Updated information on the possible presence of a crack on one of the steel chain links of the Petzl ZIGZAG and ZILLON

November 3, 2014: this message follows the July 23, 2014 communiqué

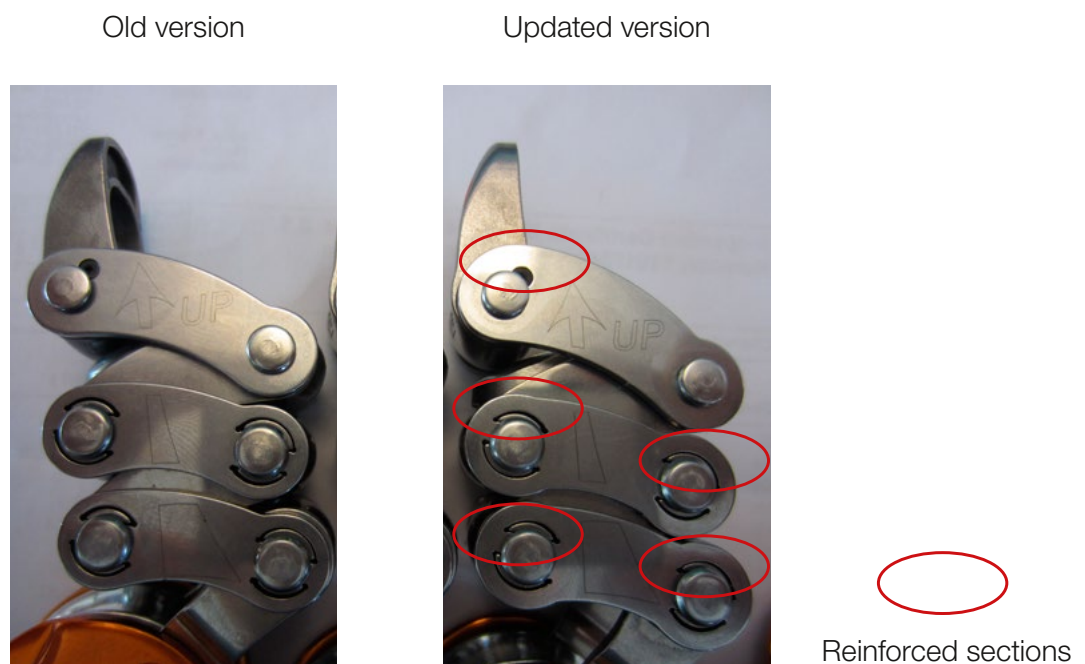
- Several ZIGZAGs with cracked friction chain links have been returned to Petzl.
- The worldwide return rate remains below 4/1000, but may be higher in some countries.
- **No incidents or accidents have been reported to us.**
- Both ZIGZAG and ZILLON friction chain links are affected.
- When a crack appears, it is always on the same side of the friction chain links.
- All devices returned to us with a cracked link have been replaced under warranty.

Petzl has identified the root causes for the appearance of these cracks. These cracks are the result of a combination of three parameters:

- Riveting parameters on one side that create a potential residual tensile stress in the friction chain link.
- The small cross section of the link near the rivet position.
- Heat treatment that results in the cross section being too rigid.

- A crack can appear over time. The gradual appearance of these cracks makes them undetectable during final factory inspection.
- Only a very low percentage of ZIGZAG/ZILLONs may potentially develop such a crack.

- Adjustment of the riveting parameters for the link assembly to eliminate residual tensile stress in the link.
- Adjustment of heat treatment parameters for the link to reduce rigidity of the material.
- Reinforcement of the small cross section of the affected links.

- A cracked link presents no additional immediate risk to the user. However, as with any personal protective equipment (PPE), the presence of such a crack requires immediate retirement of the device.
- Considering the very low rates of potentially cracked links, and taking into consideration that a cracked link presents no additional immediate risk to the user, only cracked devices will be replaced.
- The replacement of a cracked device will be done under warranty. The warranty for this defect has been extended to 10 years.
- Regularly inspect your device in accordance with the Petzl PPE checking procedure.
- In the unlikely event you find a cracked link, retire your device immediately and contact the Petzl distributor in your country.
